METROPOLITAN GOVERNMENT OF NASHVILLE AND DAVIDSON COUNTY

STAFF RECOMMENDATION
405 Chapel Avenue
March 21, 2012

Application: Infill and Demolition
District: Eastwood Neighborhood Conservation Zoning Overlay
Council District: 06
Map and Parcel Number: 08302011100
Applicant: Mitch Hodge, AIA
Project Lead: Robin Zeigler, robin.zeigler@nashville.gov

<p>Description of Project: Applicant proposes to demolish the non-contributing house at 405 Chapel and construct a new single-family home.</p> <p>Recommendation Summary: Staff recommends approval of infill construction at 405 Chapel Avenue with the conditions that:</p> <ol style="list-style-type: none"> 1. The upper level be redesigned to match the context in terms of form; 2. The driveway be a strip driveway at least to the front wall of the house; 3. Final design for materials be approved by staff; and 4. A window be added to the ground floor on the right side. <p>With these conditions, staff finds that the project meets the design guidelines for the Eastwood Neighborhood Conservation Zoning Overlay.</p>	<p>Attachments A: Photographs B: Site Plan C: Elevations</p>
---	--

ELEVATIONS
SD-3
PROJECT: 1205
DATE: 03.07.12

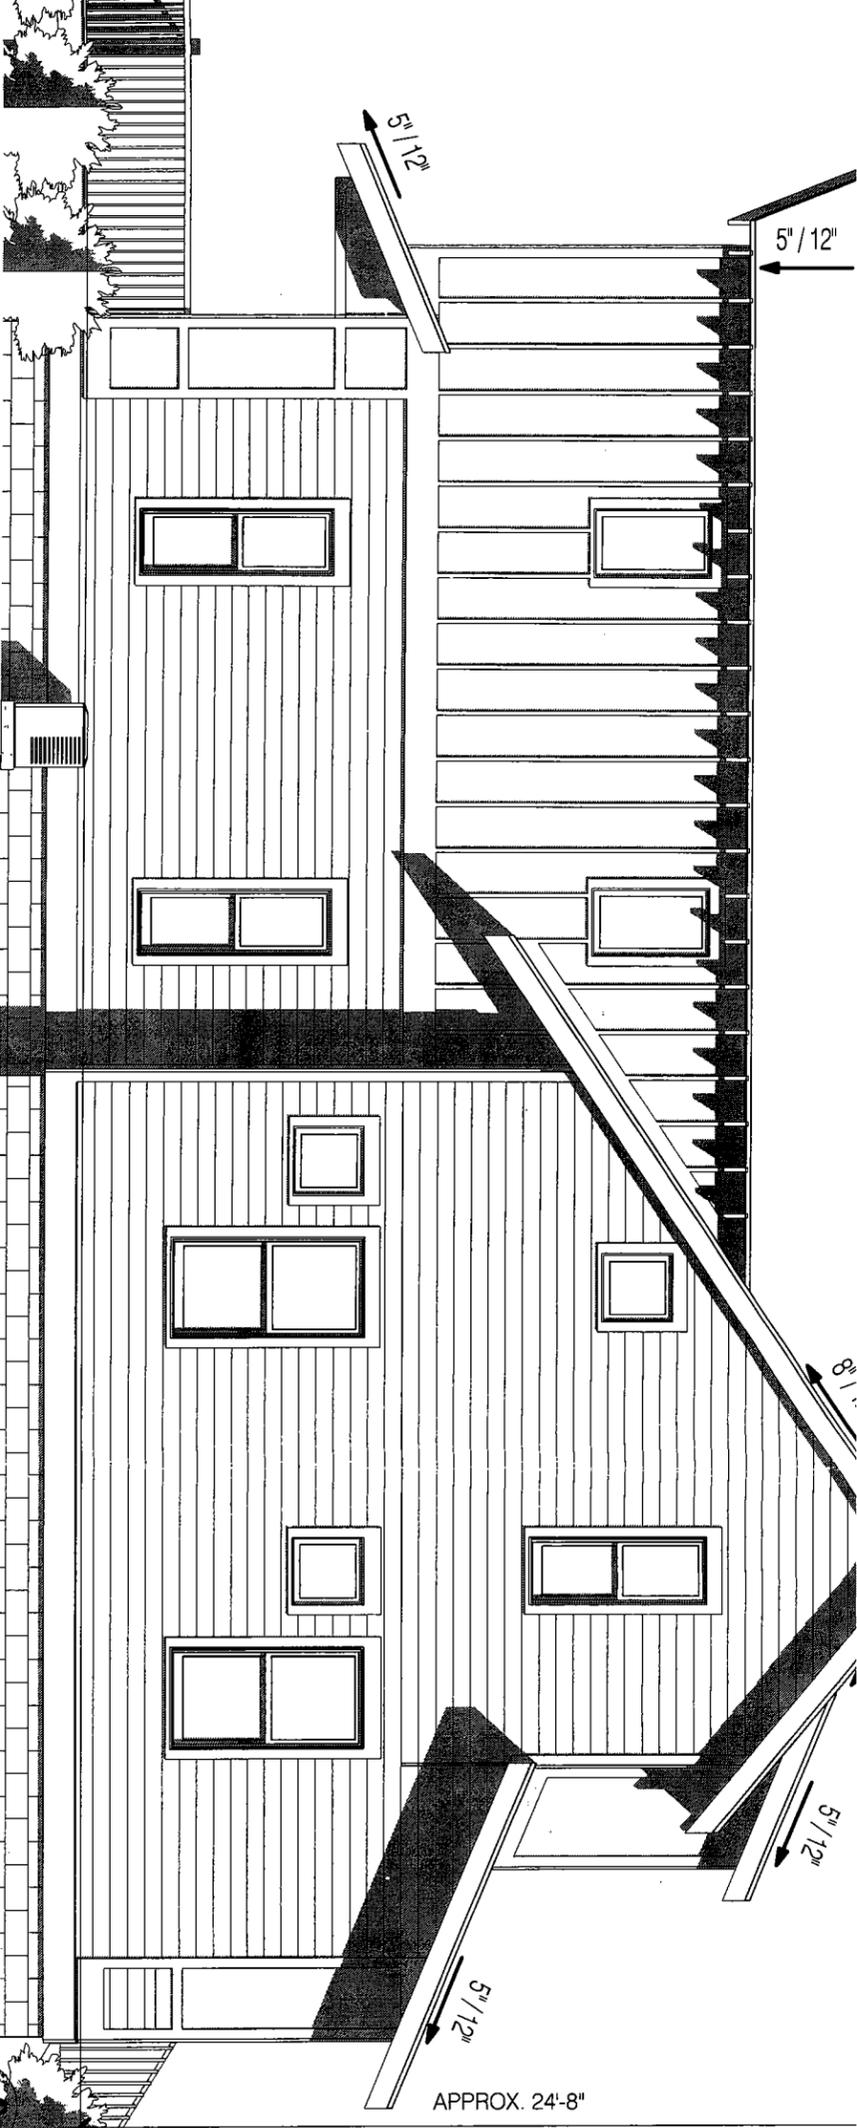
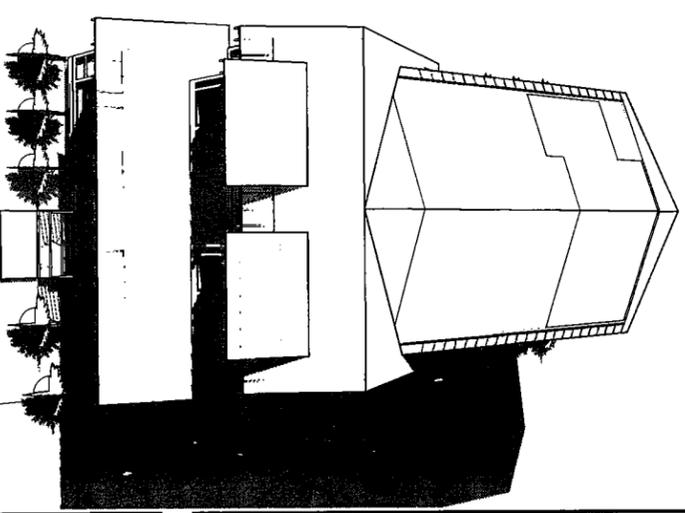
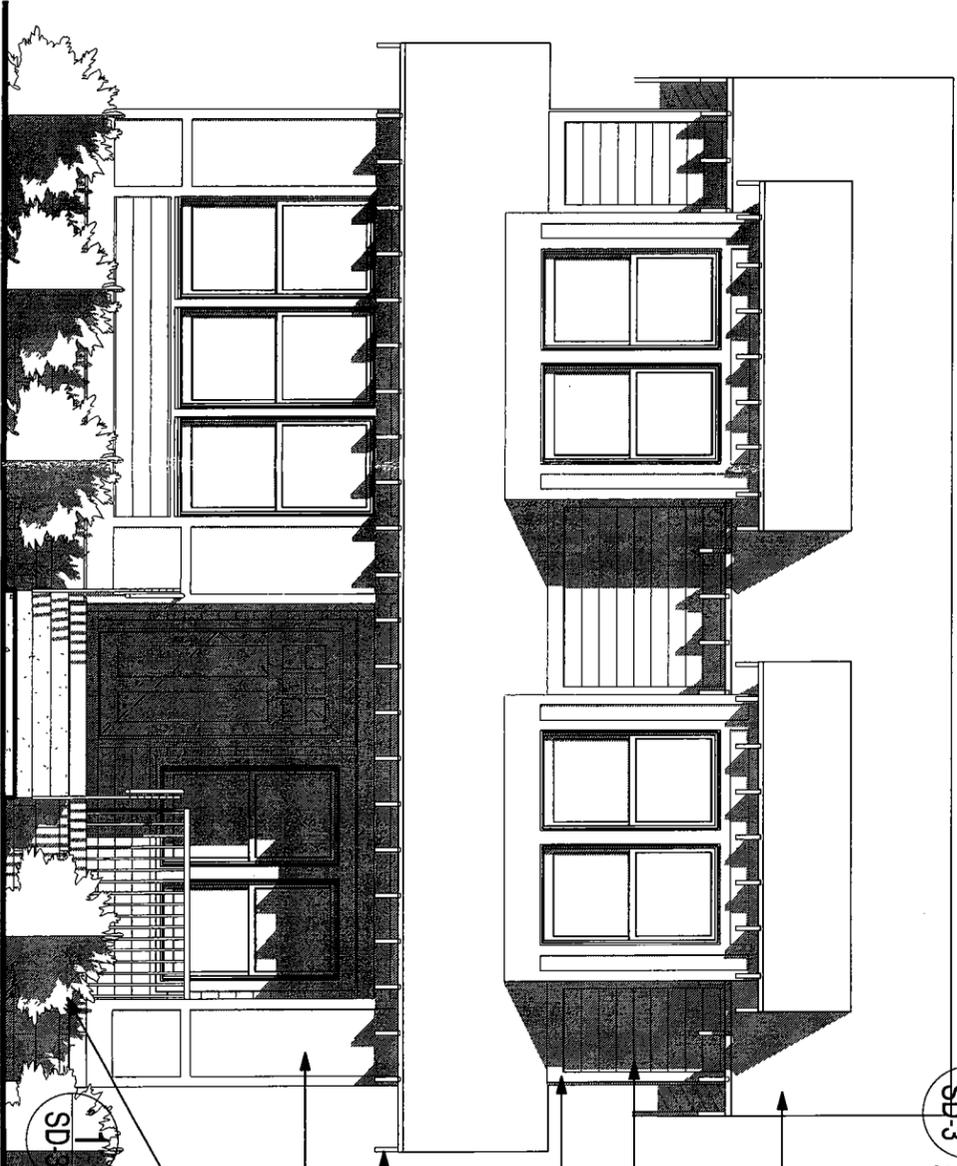
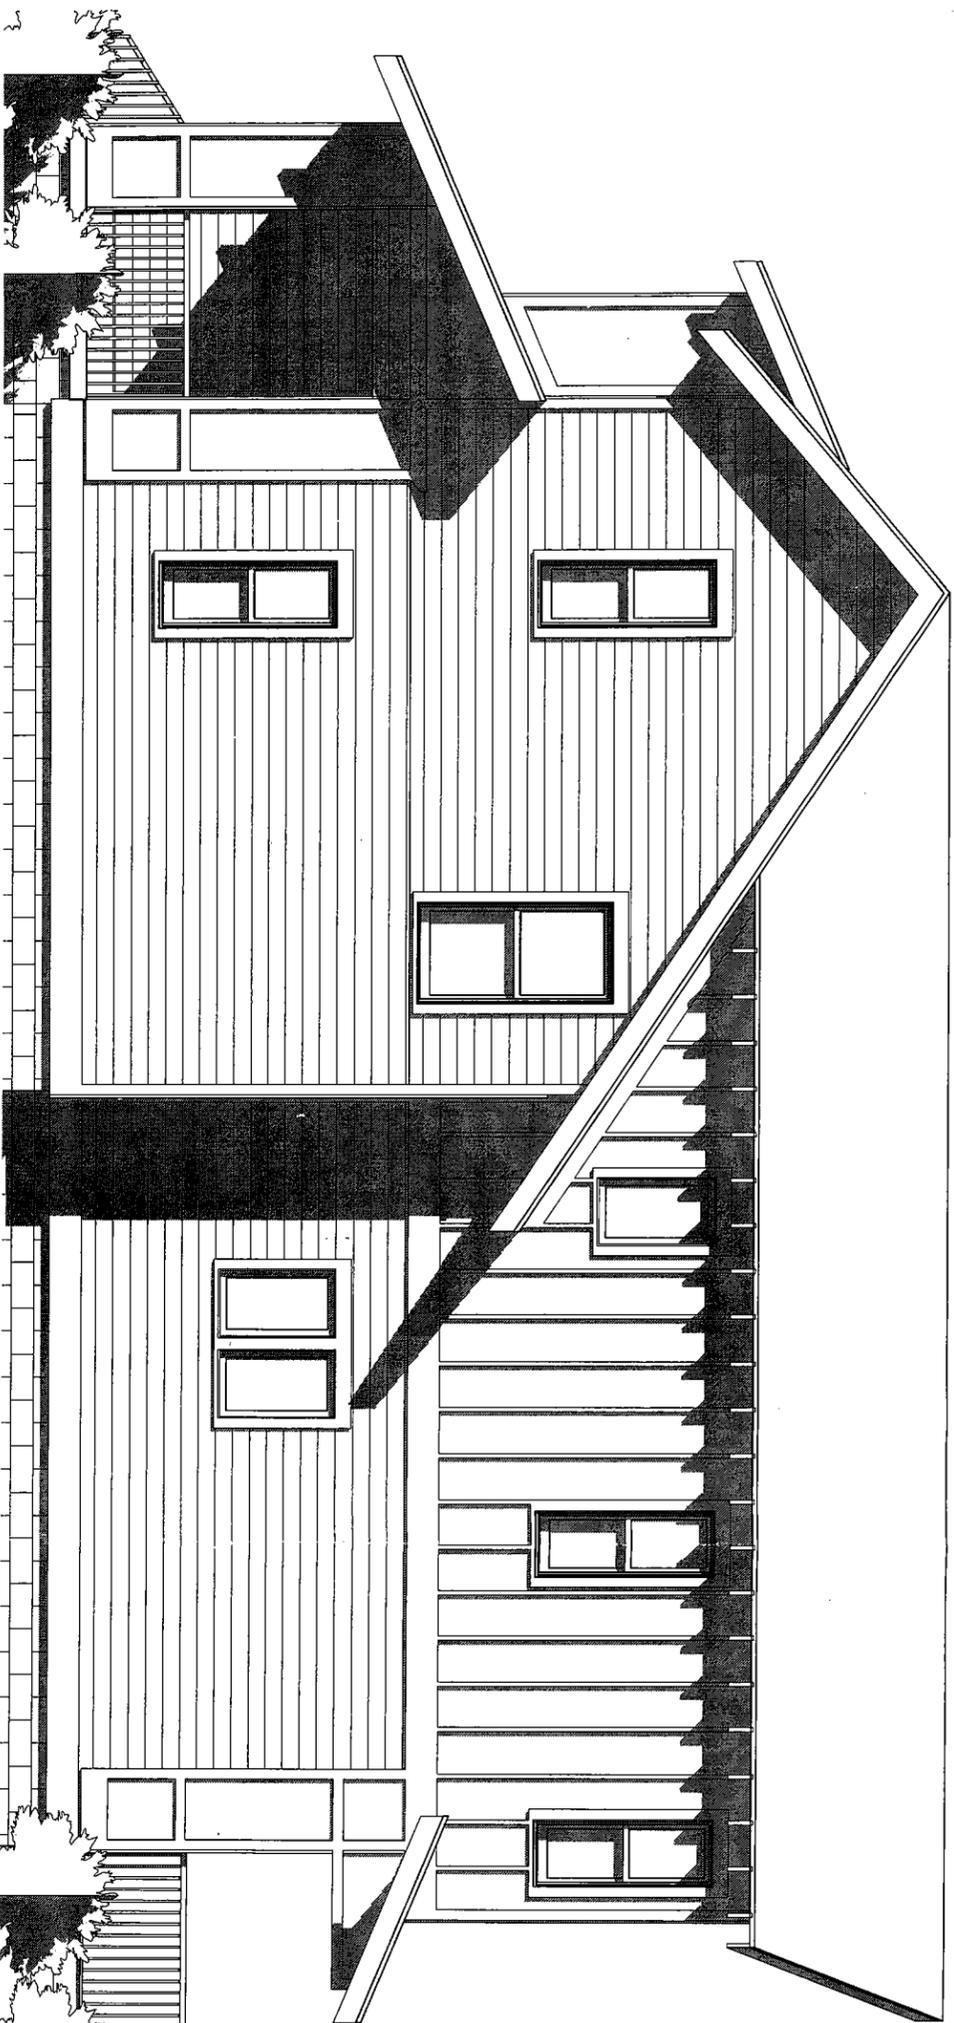
The home does not match the context in terms of form with the two dominate projecting wall dormers, an asymmetrical gable, a porch roof that projects beyond the width of the house, and a pushed back upper level. Wall dormers are rarely seen in this district and accentuate height. On the right side, the dormers project beyond the wall below. Staff recommends a redesign of the second level to a form more compatible with the historic context.

The roof pitches vary; however the pitches of the main body of the front portion of the house are 10/12 and 8/12. In the past, the commission has required a minimum of 6/12. The rear portion and the porches are 5/12. Although the pitches themselves matches the context, the severely asymmetrical gable created by pushing back the front wall of the second floor creates a form not found in the district. Staff recommends a redesign of the second level to meet section II.B.1.e.

The majority of windows are twice as tall as they are wide, matching the historic context. The majority of facades have a rhythm of solids-to-voids which meets the context with the exception of the right side which has an expanse of thirteen feet (13') of solid wall space on the first floor. Since this area is close to the front, staff recommends adding an additional window to the first floor. A shuttered faux window could be added to the closet or a small window could be added to the stairwell. With the addition of this window, staff finds that the project meets section II.B.1.g of the design guidelines.

5. The upper level be redesigned to match the context in terms of form;
6. The driveway be a strip driveway at least to the front wall of the house;
7. Final design for materials be approved by staff; and
8. A window be added to the ground floor on the right side.
